**2008 EASTON POINT  
RESIDENTIAL  
DEVELOPMENT**

***Final Environmental Impact  
Report***

***Response to Comments to the  
Draft Environmental Impact  
Report***

*State Clearinghouse No. 2009012010*

# Exhibit 9.0-1 Construction Road Plan and Profile

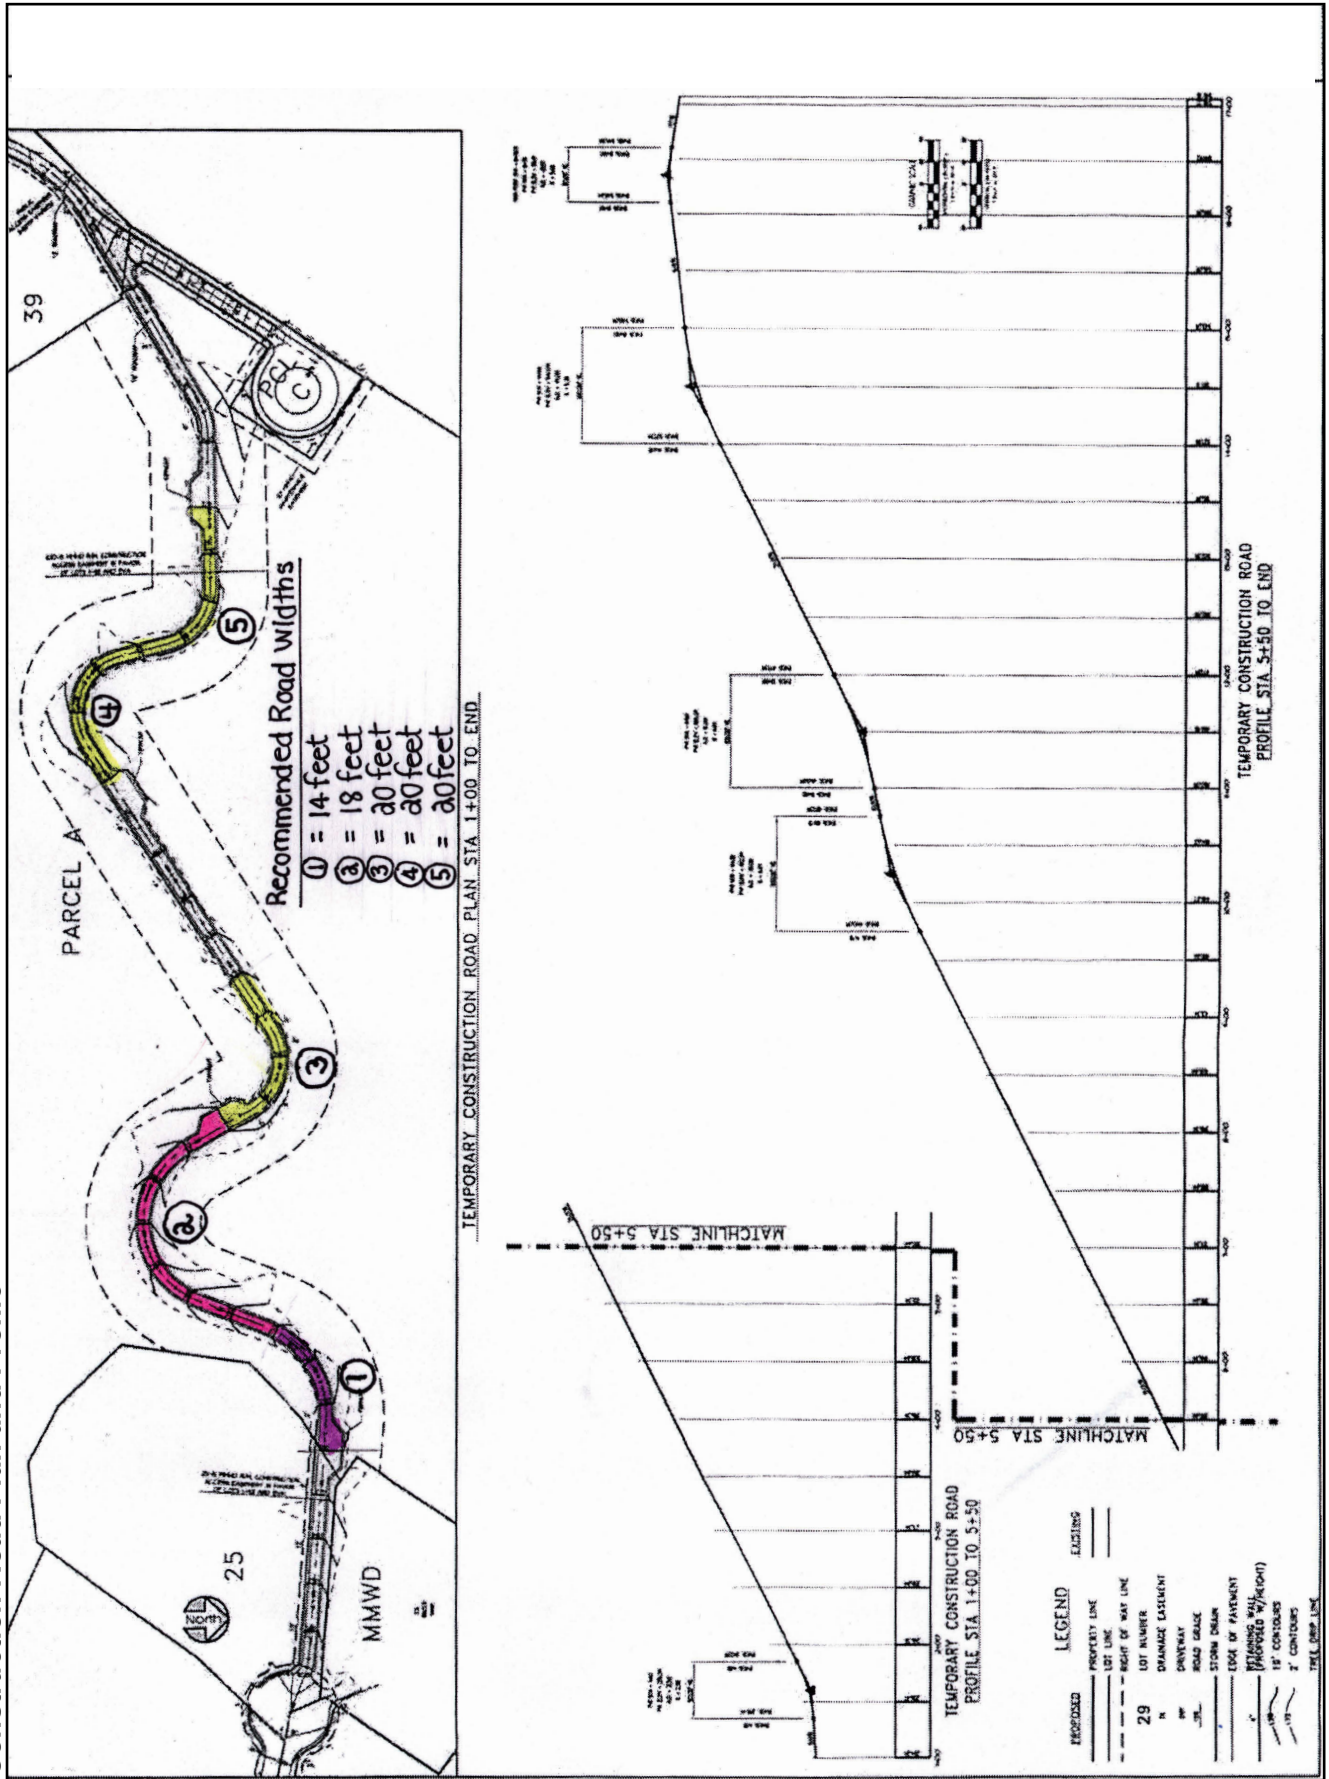
The increased width of the construction road in selected locations would not result in new environmental impacts beyond those already discussed in the EIR. The wider road would be located primarily along the ridge. The additional grading associated with the wider road would require cuts into firm Franciscan Bedrock. Accordingly there would be no additional geologic impacts. Compared to the construction road evaluated in the Draft EIR the retaining walls would not be significantly different. The earthwork generated would be roughly 5,000 cubic yards of cut and 2,000 cubic yards of fill, resulting in 3,000 cubic yards of off-haul. For the construction road evaluated in the Draft EIR there would be approximately 3,430 cubic yards of cut and 526 cubic yards of fill for a net 2,904 cubic yards of off-haul.<sup>5</sup> Although there would be more grading, it would generate roughly the same amount of off-haul. The increased construction road width would result in an increased impervious area. This would not result in a significant increase in the severity of on-site drainage patterns or impact to groundwater recharge discussed in the Draft EIR. The increased road width could result in a small amount of additional loss of oak woodland habitat, already considered a significant impact. Mitigations are already included in the EIR that would reduce this impact to a less-than-significant impact.

**Exhibit 9.0-2**  
**Emergency Radio Facility Pad**

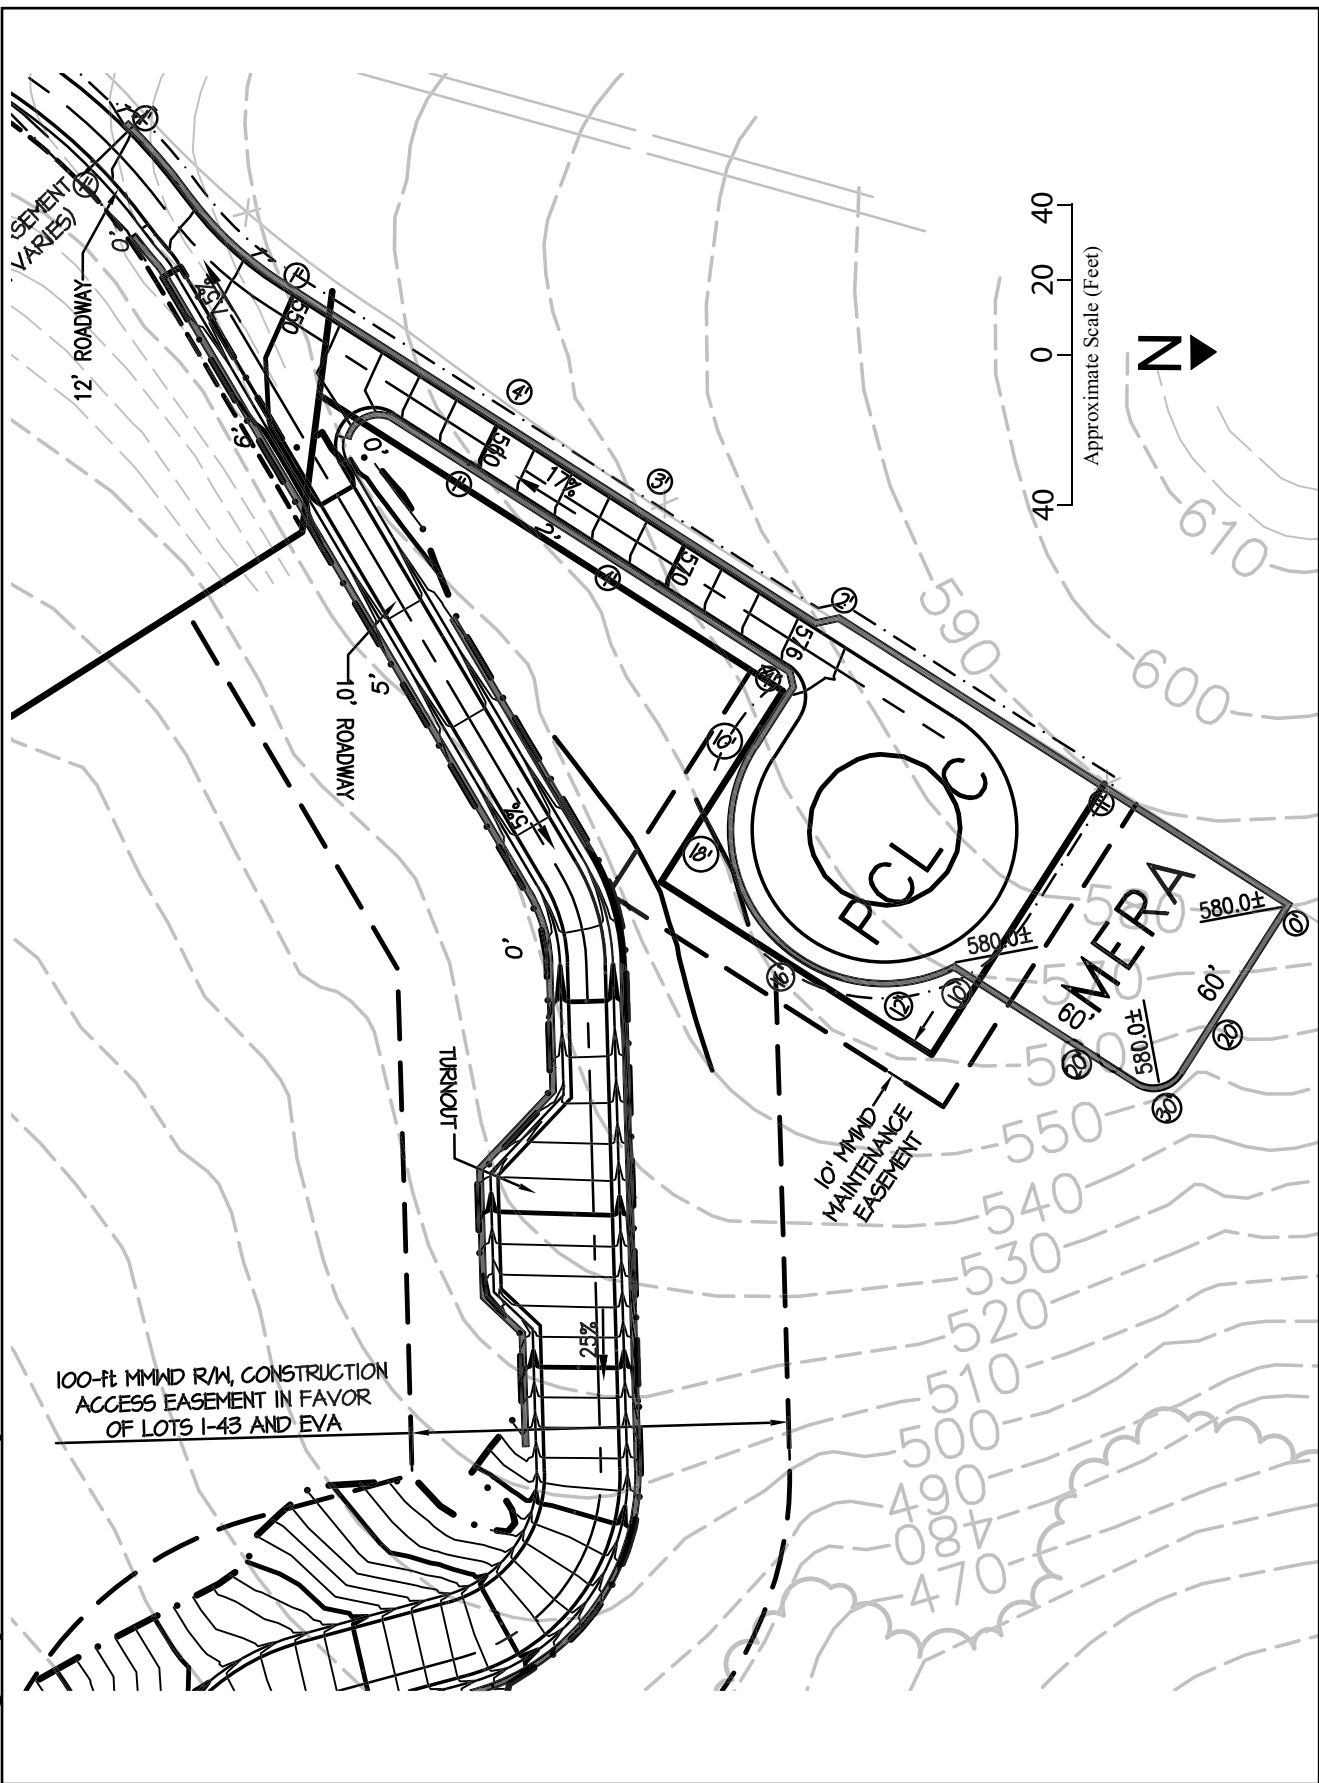
The proposed location of the emergency radio facility was reviewed to determine the proximity of the proposed site to the existing landslides (see **Exhibit 5.4-1**). A portion of the proposed site would be located on Landslide 20. This landslide was proposed to be improved but not repaired in the Conceptual Landslide Stabilization Plan prepared by the applicant's geotechnical consultant (see **Exhibit 5.4-2** and page 344 of the Draft EIR). Therefore, if the emergency radio facility site is located on Landslide 20, the landslide should be completely repaired, rather than improved, in order to be consistent with the Conceptual Landslide Stabilization Plan. It is Snyder & Wilson's (the EIR geology analyst) opinion that this small landslide could be easily stabilized using a graded buttress or piles designed similar to the other repairs presented by Miller Pacific to stabilize other landslides in the Conceptual Landslide Stabilization Plan (see **Exhibit 5.4-2**). Care should be taken to control all surface drainage runoff on the building pad, so that it does not flow uncontrolled down the slope and adversely affect slope stability.

At the request of County staff the applicant did provide a site adjacent to Parcel C for an emergency radio facility. The site is adjacent to and just northeast of the proposed new water tank near the project's northwestern boundary (see **Exhibit 9.0-2**). The pad would provide a 60-foot by 60 foot area to locate all of the necessary equipment. The pad would be graded to an elevation of 580 feet. The northwest corner of the pad would be cut into the adjoining hillslope, while the southeast and northeast corners would be elevated above the existing ground by ten to 30 feet. A retaining wall ranging in height from zero feet to 30 feet would be required. Potential impacts associated with the emergency radio facility are described below.

**Exhibit 5.5-1 (Revised)**  
**Local Hydrology**

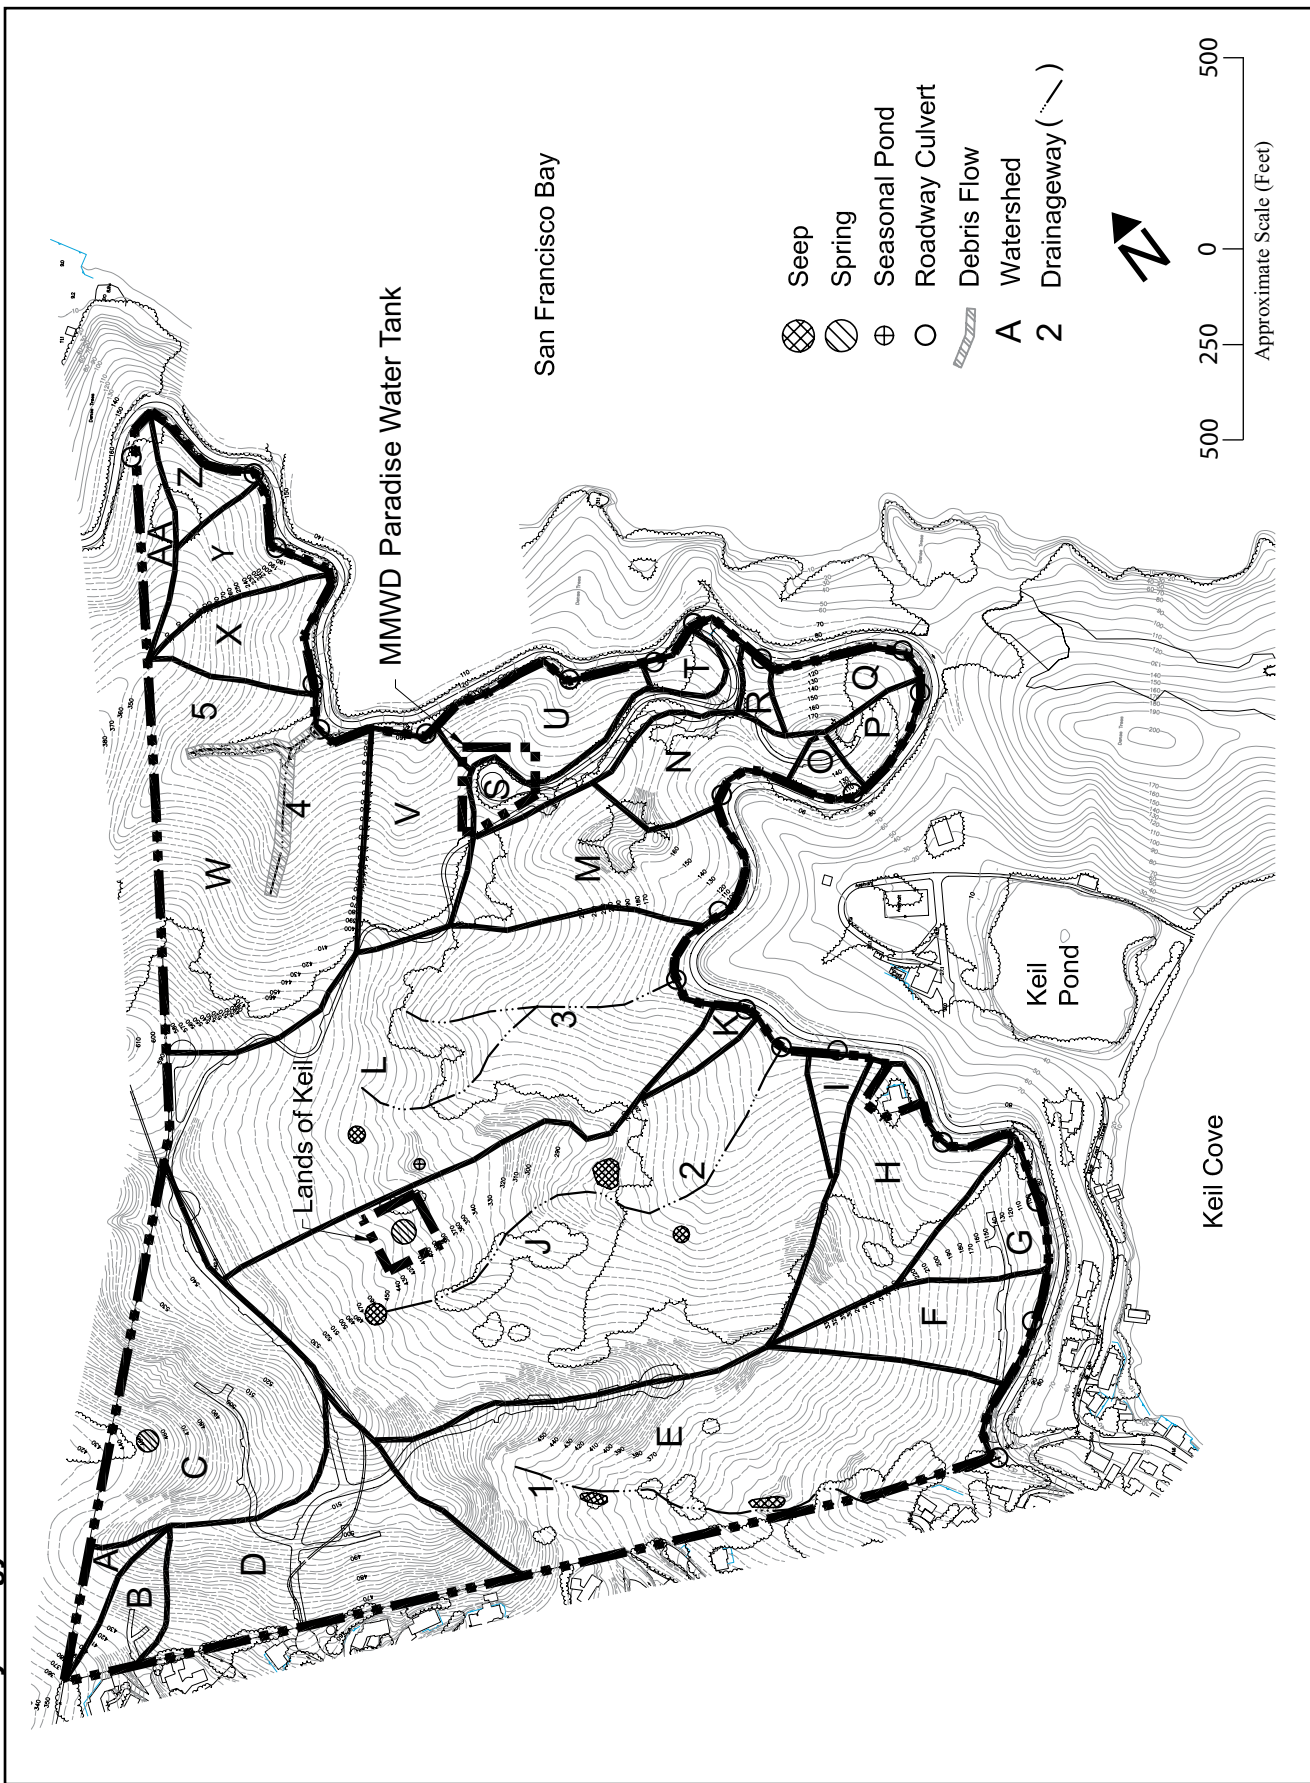
***Comment 8: Exhibit 5.5-1 Local Hydrology.***

**Exhibit 5.5-1** has been revised to correct the mislabeled watershed. The corrected exhibit is included on the next page.
